TN ERFO FS CHRKE804 2020-2(1)

Amendment No. 0002
Project TN ERFO FS CHRKE804 2020-2(1)
Cherokee National Forest
Solicitation: 693C73-26-B-000011

The purpose of this Amendment is to:

AMENDMENT NO.2	PROJECT	SHEET NUMBER
	TN ERFO FS CHRKE804 2020-2(1)	M15

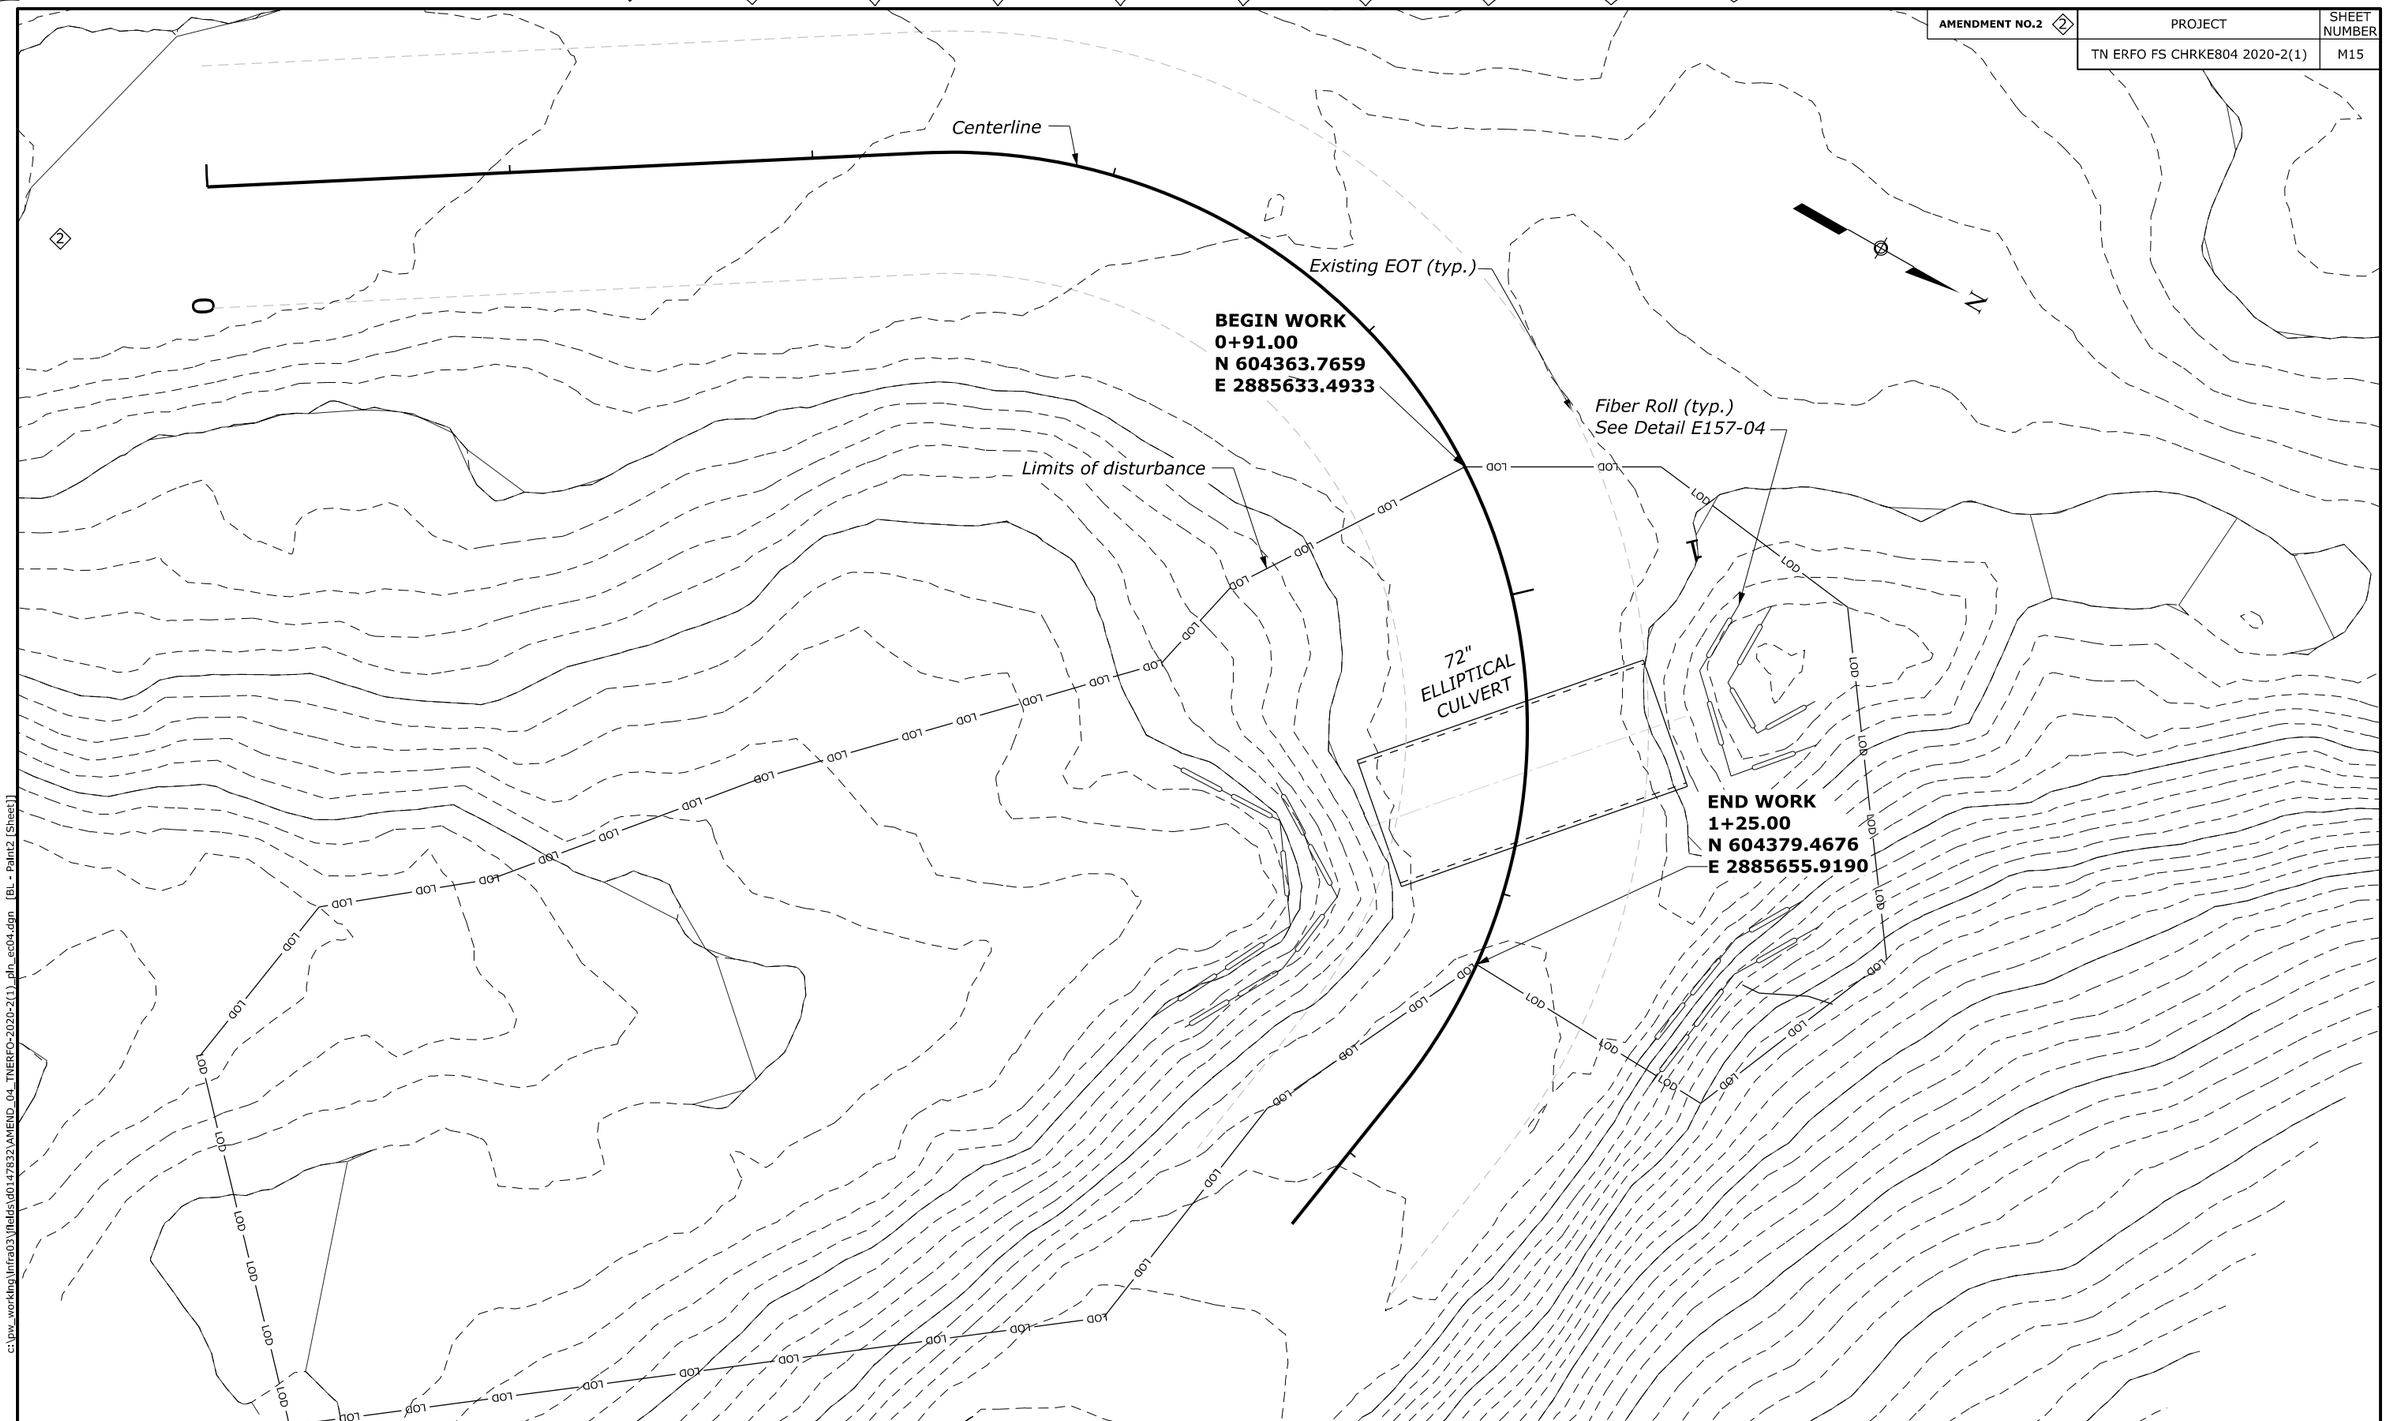
4. Sheet M15: I reviewed the E&S plan to see if the LOD indicates the length of the Class 4 riprap, but the LOD does not appear to extend to the end of the riprap placement area. **Response: The scale has been adjusted. See amended Sheet M15.**

NO.	DATE	BY	REVISIONS
2	06/15/26	JMF	AMD #2 - Revised LOD and updated viewport area.
